E5100B-29B

S E R V I C E N O T E

Agilent E5100B Network Analyzer

Replacement of Floppy Disk Drive

Figure 1

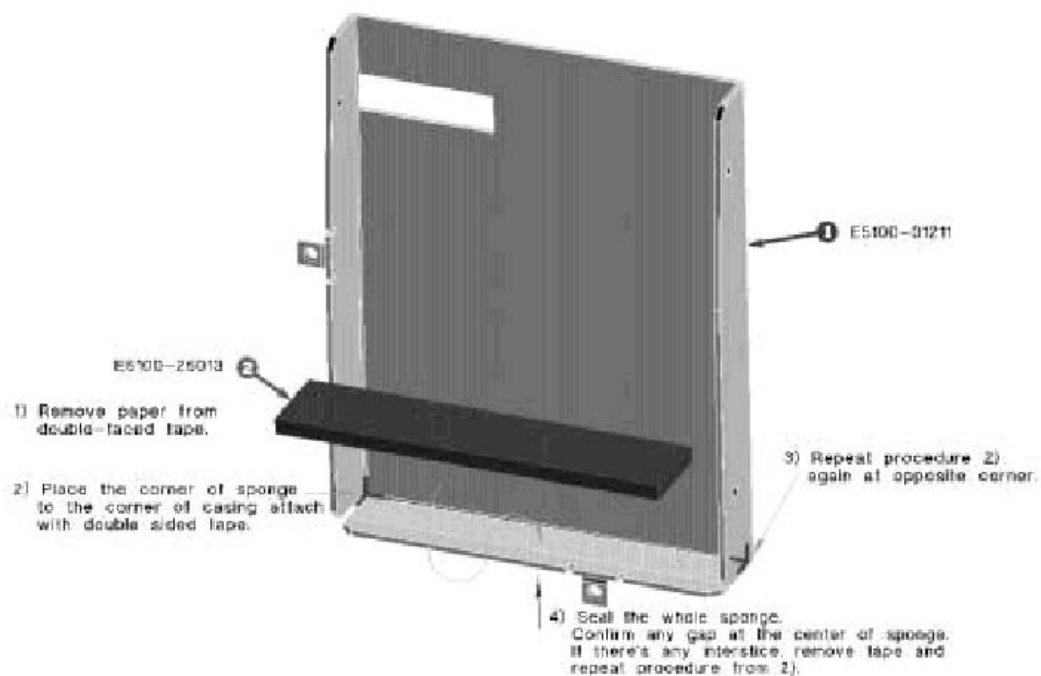
To assemble the FDD cover with sponges, see attached figures.
